### International Aero Engines

# SERVICE BULLETIN

<u>ENGINE - HP TURBINE ROTOR AND STATOR ASSEMBLY - PROVIDE A NEW STAGE 2 TURBINE BLADE</u>

<u>(FOR VARIOUS MODEL PARTS COMMONALITY) - CATEGORY CODE 7 - MOD.ENG-72-0187</u>

Location of the Stage 2 HPT Blade Assembly Fig.1

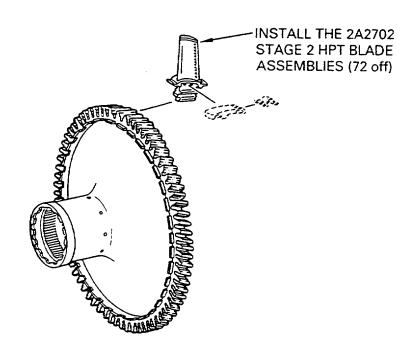
(1) Replace the Stage 2 Turbine Rotor Blade with one that is common with the V2500-D5 Engine.

- (1) Install the 2A2702 Stage 2 HPT Blade Assemblies (72 off) by the approved procedure given in Reference (2), Chapter/Section 72-45-30, Assembly, and Figure 1.
- (2) Identify the Stage 2 Turbine Rotor Assembly by the procedure given in Reference (3), Chapter/Section 70-09-00, Marking of Parts.
  - (a) Mark the new part number, 2A2622, adjacent to the old part number, 2A2822.
  - (b) Use the vibration peen method.
- (3) When you install the Stage 2 Turbine Rotor Assembly by the procedure given in Reference (2), Chapter/Section 72-45-00 Assembly identify the HPT Rotor and Stator Assembly Module as follows:
  - (a) Use the procedure given in Reference (3), Chapter/Section 70-09-00, Marking of Parts.
  - (b) Mark the new part number, 2A7000, adjacent to the old part number, 2A4200.
  - (c) Use the vibration peen method.
